SE73-40

SUBJECT: VERTICAL FIN ATTACHMENT IMPROVEMENT

AIRCRAFT AFFECTED: Model 177, 177RG and F177RG's in the following serial blocks:

Figure 1. Vertical Fin Attachment Bulkhead Inspection.

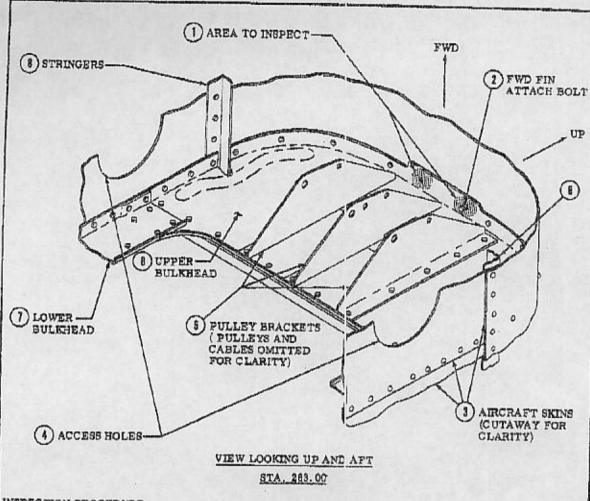
An improved vertical fin forward attachment bulkhead (P/N 1712104-11), which incorporates a stiffner in the area shown in Figure 1, has been phased into production on Cardinal and Cardinal RG series aircraft.

It is important that a careful inspection of the forward attachment bulkhead on affected in-service aircraft be accomplished within the next 100 hours of operation and at each periodic inspection thereafter as shown in Figure 1.

Cracking around the vertical fin attachment bolt holes will require that bulk-head assembly be replaced with the improved configuration bulkhead by installing the applicable Service Kit as shown below.

- REMOVE DORSAL FIN BY REMOVING ATTACHING SCREWII.
- 2. REMOVE FORWARD ACCESS COVERS FROM HOLES (4).
- 3. REMOVE NUTS AND WASHERS FROM BOLTS (2). MOVE BOLTS UP SO THAT LOWER SURFACE OF BULKHEAD FLANGE (6) AROUND FIN ATTACH HOLES CAN BE INSPECTED.
- 4. USING AN INSPECTION MIRROR AND LIGHT, CLOSELY INSPECT SHADED AREAS (1) FOR CRACKS.
- 5. IF CRACK IS FOUND ONE OF THE FOLLOWING SERVICE KITS WILL BE REQUIRED IN ACCORDANCE WITH AIRCRAFT SERIAL NOTED.
